SOLICITATION AMENDMENT

Title - Sujet South Substation Switchgear Replace	
Solicitation No. - N° de l'invitation EZ108-162126/A	Amendment No. - N° modif. 007
Client Reference No. - N° de référence du client	Date 2016-03-21
GETS Reference No. - N° de référence de SEAG PW-\$PWY-026-7753	
File No. - N° de dossier PWY-5-38400 (026)	CCC No./N° CCC - FMS No./N° VME
Solicitation Closes - L'invitation prend fin at - à 02:00 PM on - le 2016-03-29	
Time Zone Fuseau horaire Pacific Daylight Saving Time PDT	
F.O.B. - F.A.B. Plant-Usine: <input type="checkbox"/> Destination: <input checked="" type="checkbox"/> Other-Autre: <input type="checkbox"/>	
Address Enquiries to: - Adresser toutes questions à: Liu (PWY), Patty	Buyer Id - Id de l'acheteur pwy026
Telephone No. - N° de téléphone (604) 775-6227 ()	FAX No. - N° de FAX (604) 775-6633
Destination - of Goods, Services, and Construction: Destination - des biens, services et construction: PWGSC - Esquimalt Graving Dock - Victoria, BC

Amendment 007 has been raised to incorporate Addendum no. 3.

Project title/Titre du projet
ESQUIMALT GRAVING DOCK
SOUTH SUBSTATION SWITCHGEAR REPLACEMENT PROJECT
825 ADMIRALS ROAD, VICTORIA, B.C., V9A 2P1

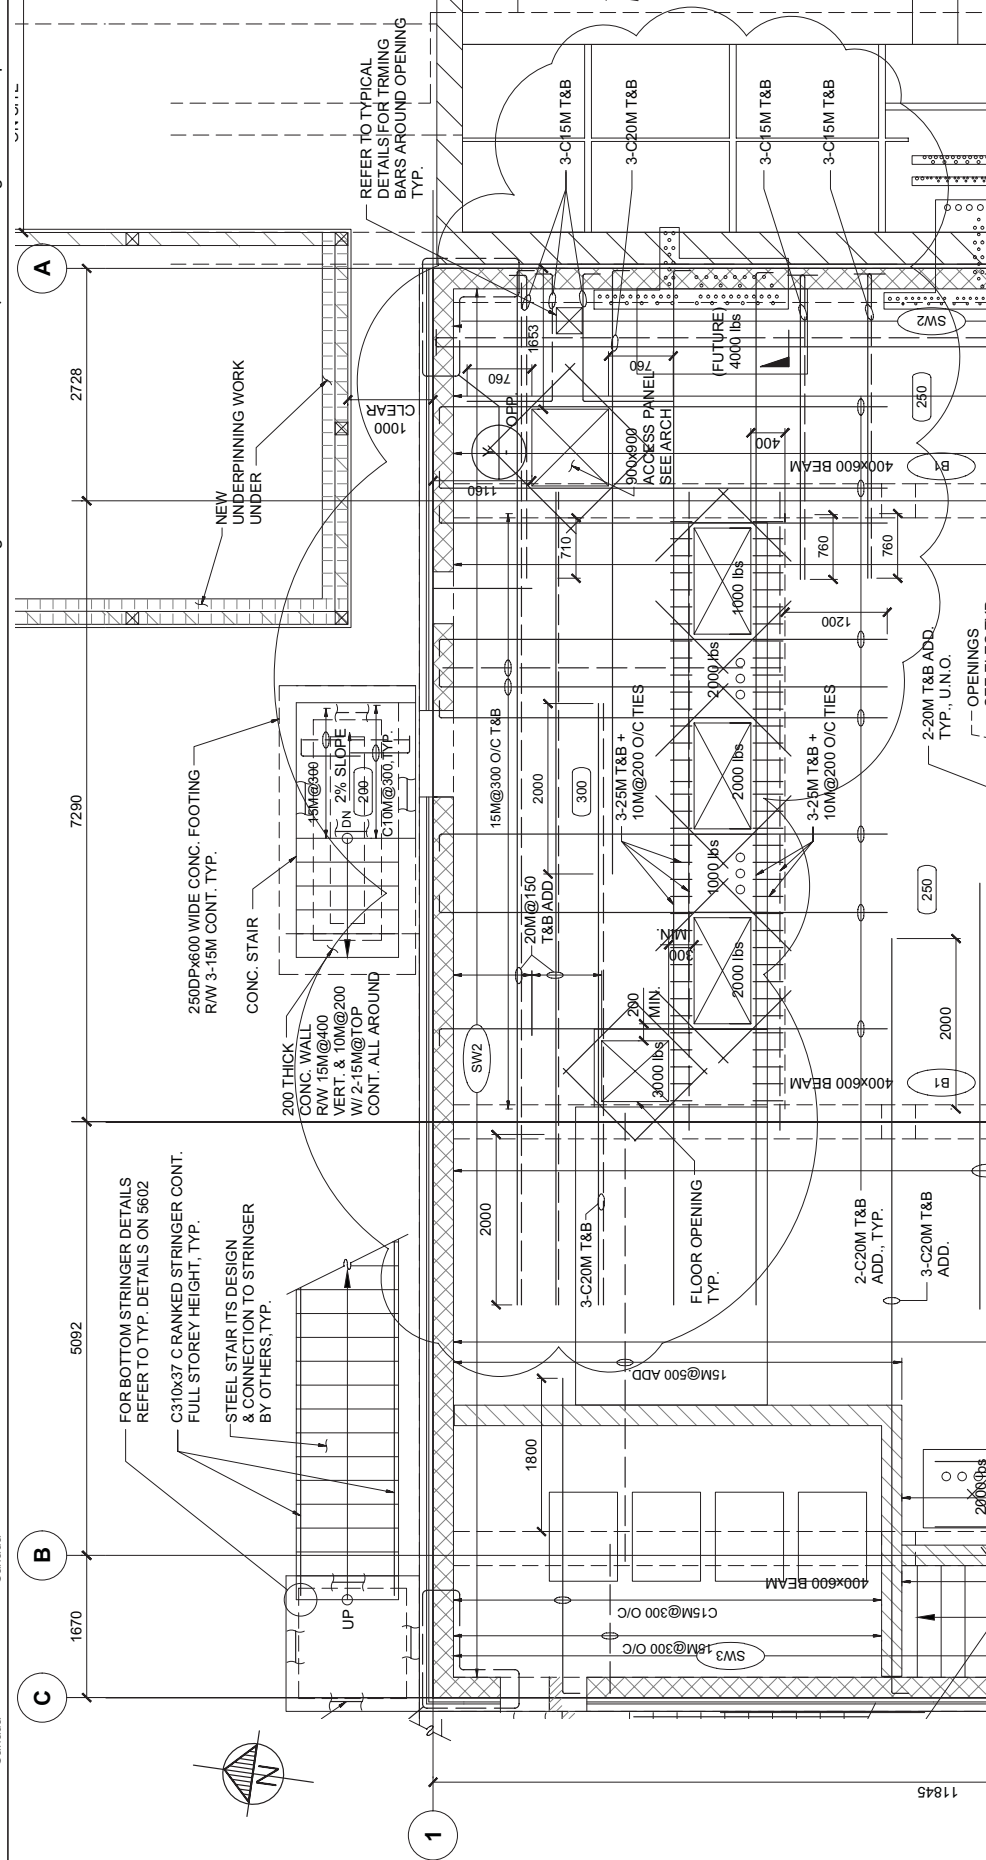
- 1.1 **REVISE** Main floor part plan as per attached addendum sketches AD-S02.
-
